Appendix A

Response-to-comment

Lot Nos. 314 RP (Part), 315 (Part),
317 S.F, 317 S.G (Part), 317 S.H
(Part) & 317 S.I RP in D.D. 113,
Ma On Kong, Pat Heung,

Proposed Drainage Layout Plan

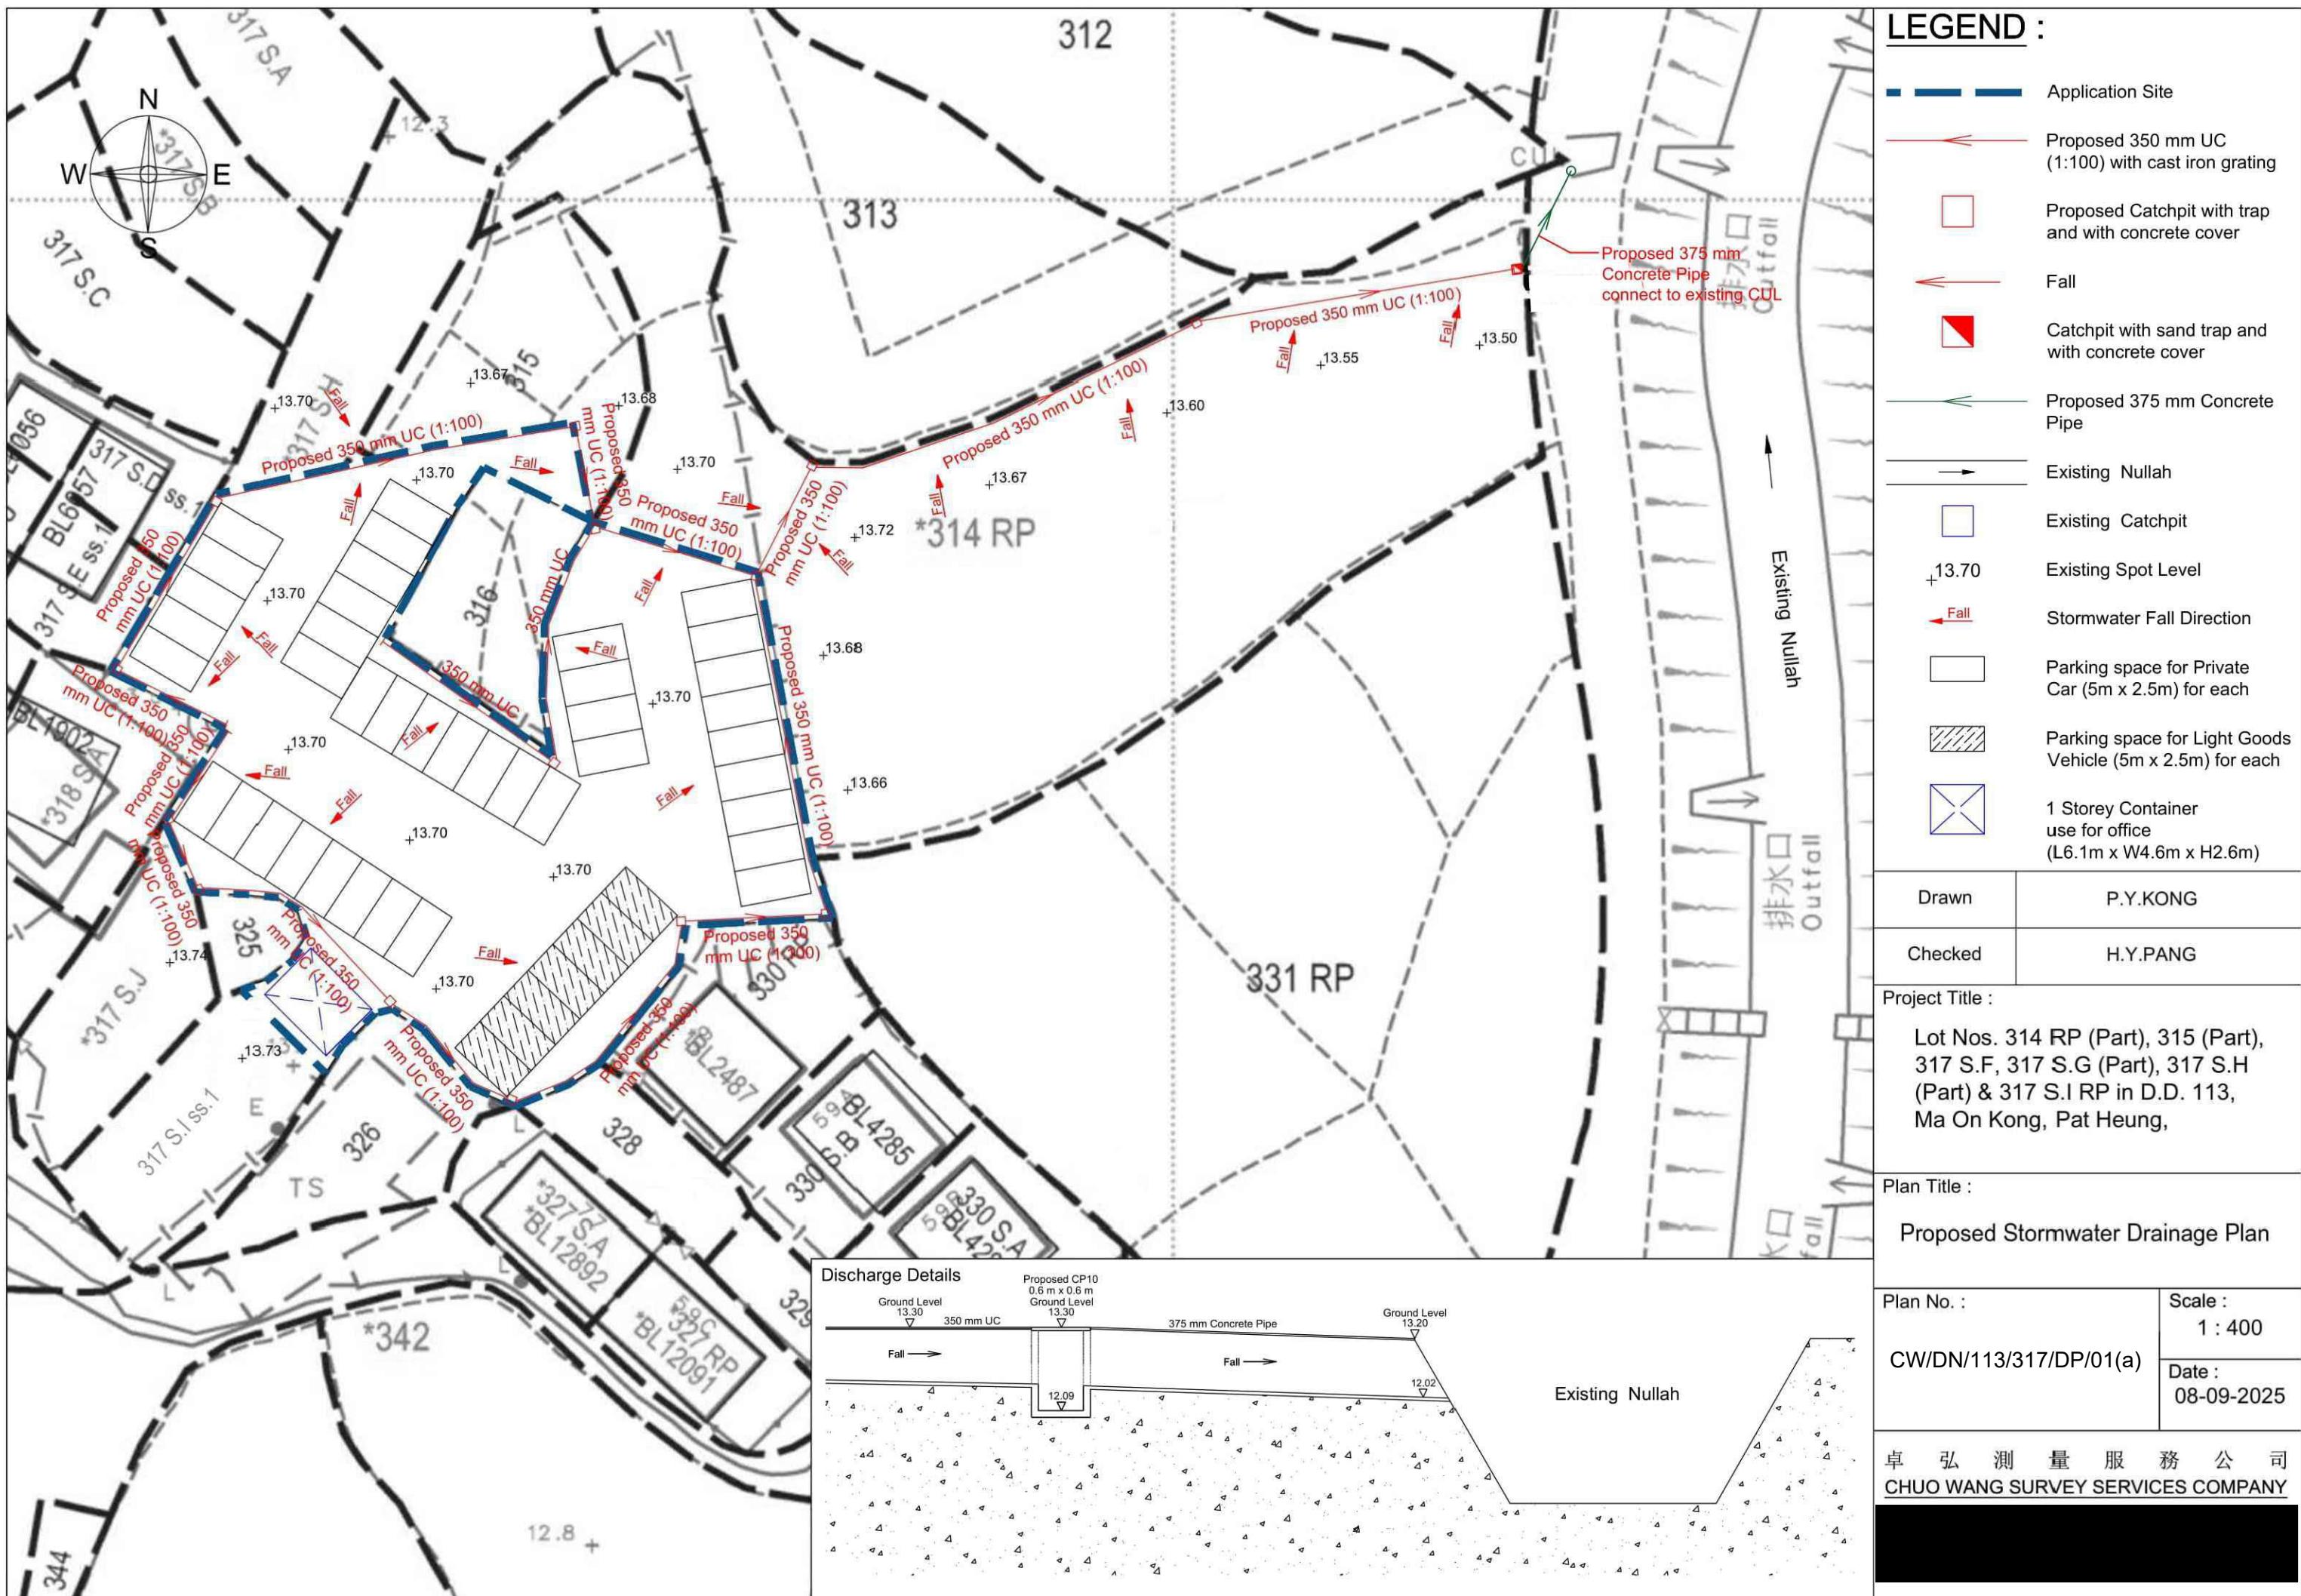
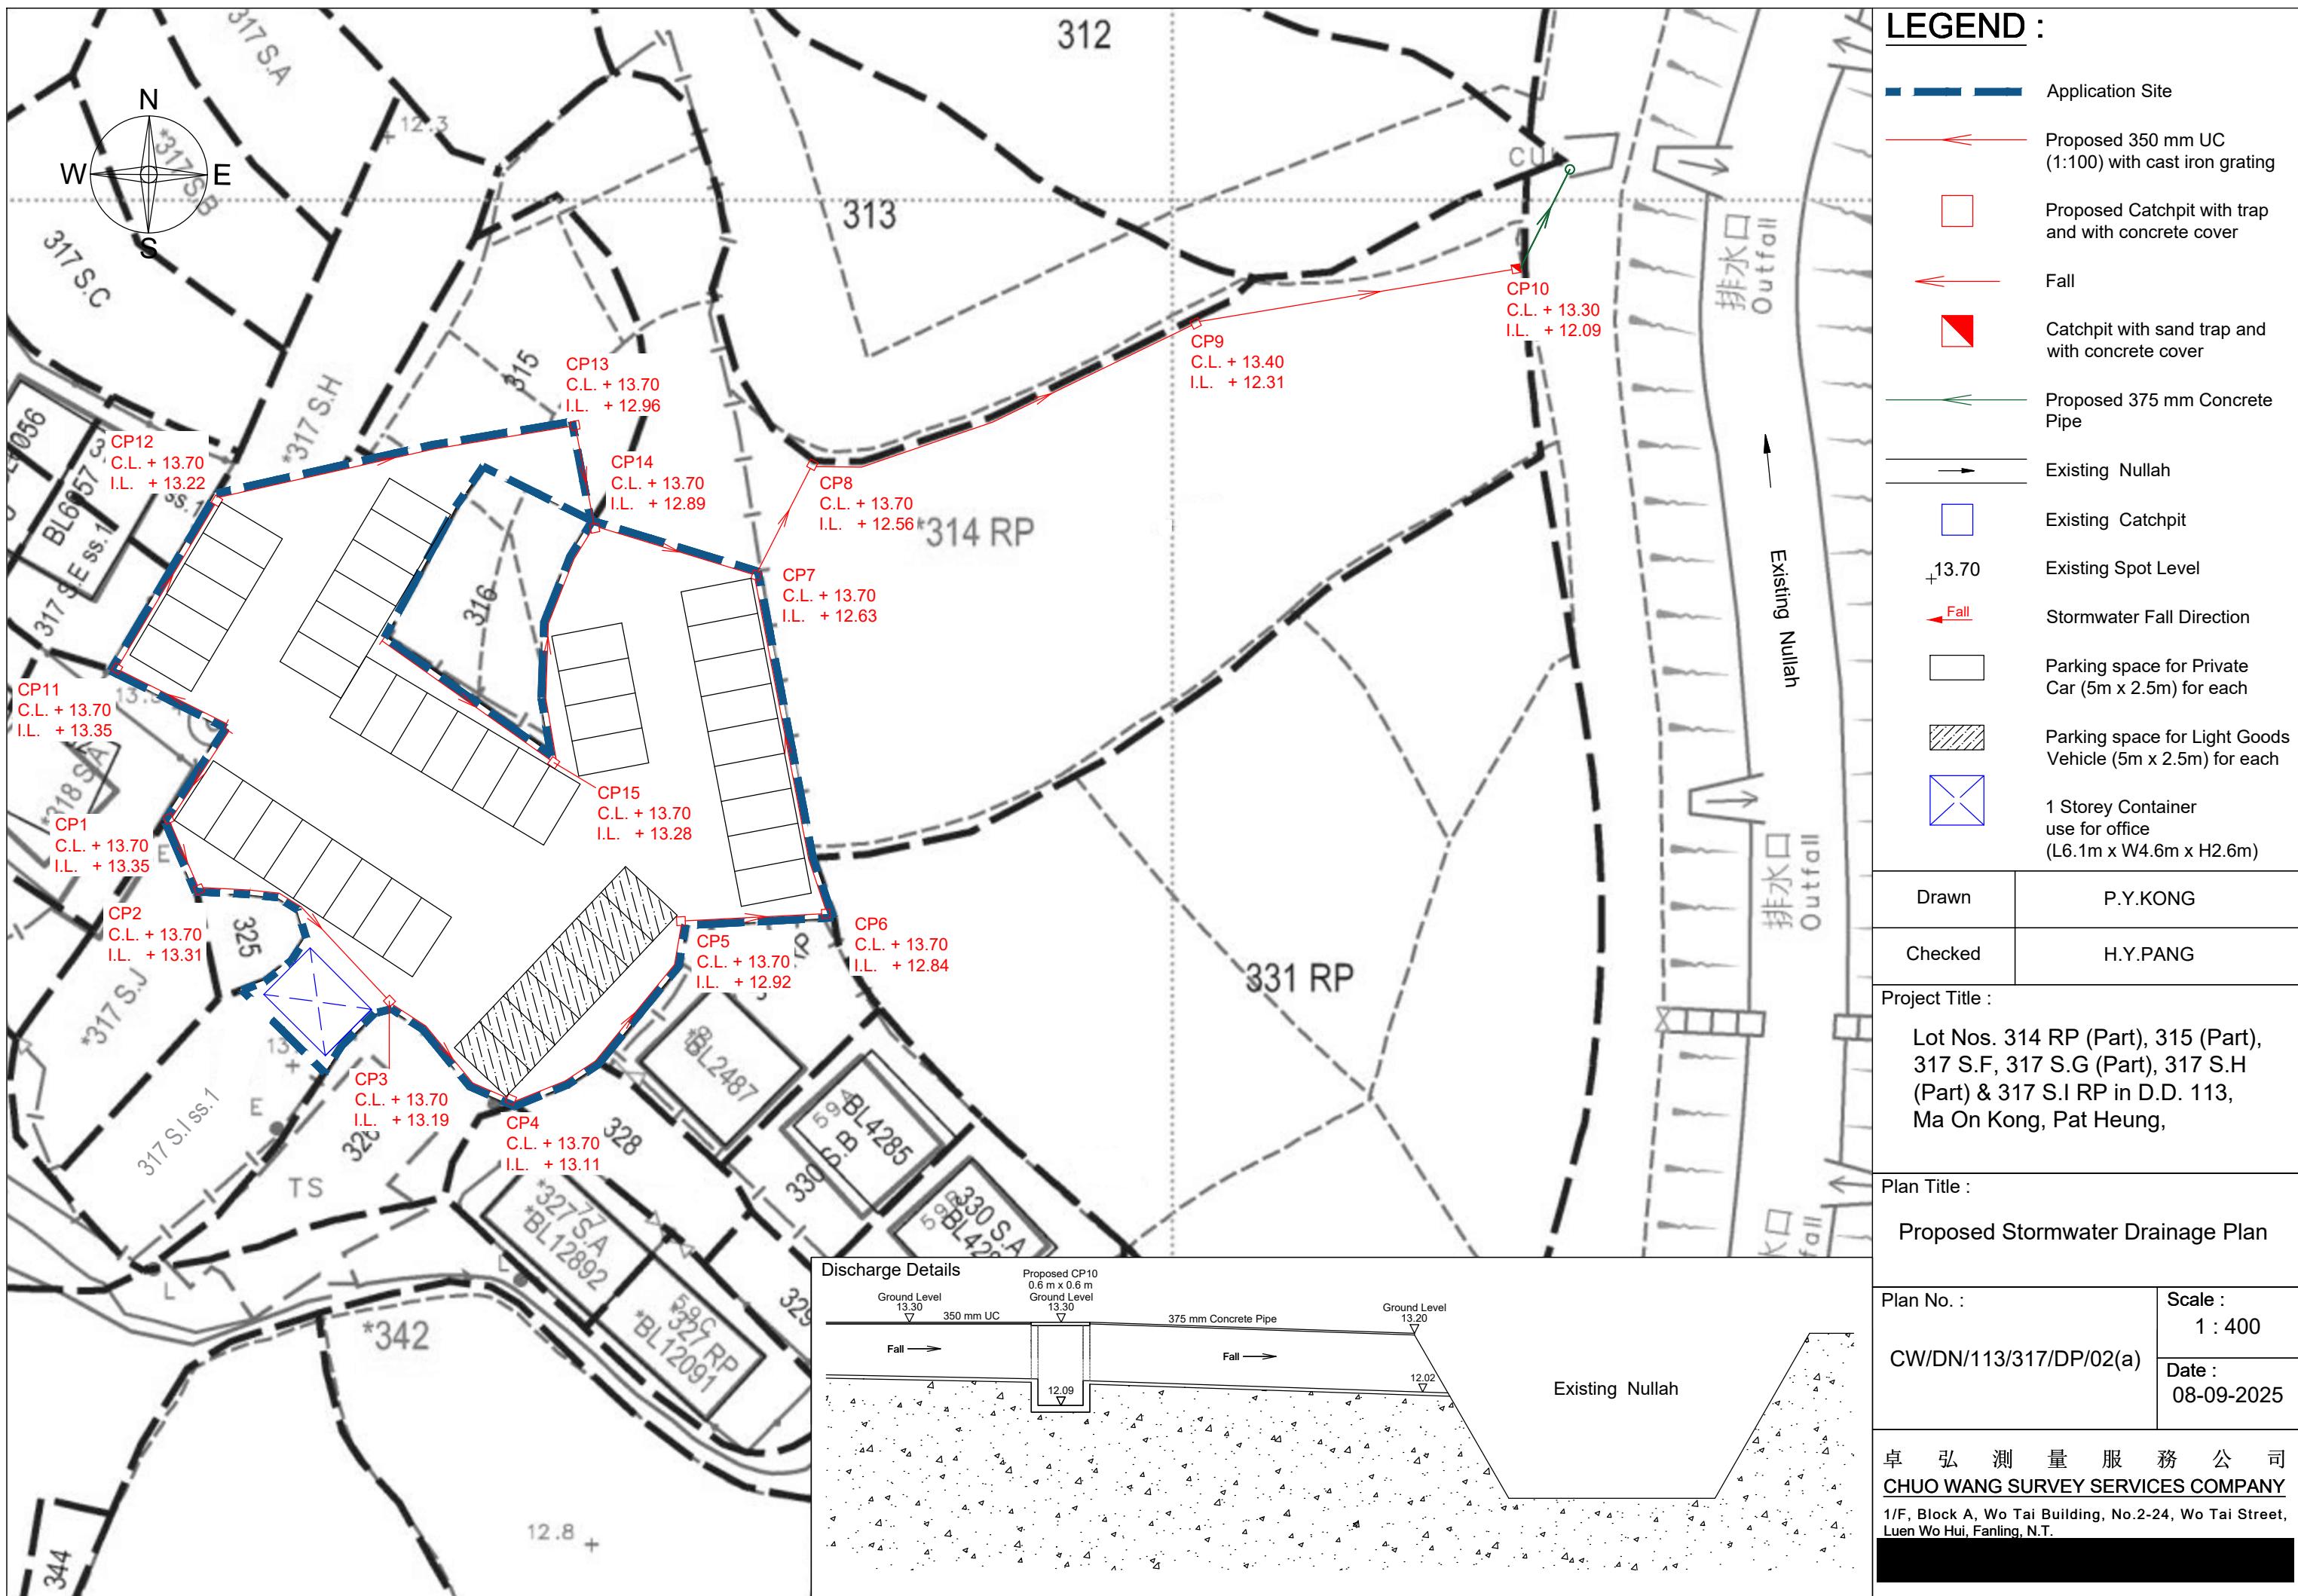
(f)	There is calculation for proposed drainage pipe. However, no drainage pipe is found in Plan Nos. CW/DN/113/317/DP/01(a) and CW/DN/113/317/DP/02(a).	The drawings and calculation sheet are updated.

(i)	Please replace the channel after CP10 by a drainage pipe.	The drawing is updated.
(j)	Please consider to discharge the intercepted stormwater into the nearby belt-mount instead of discharging into the existing channel.	The drawing is updated.
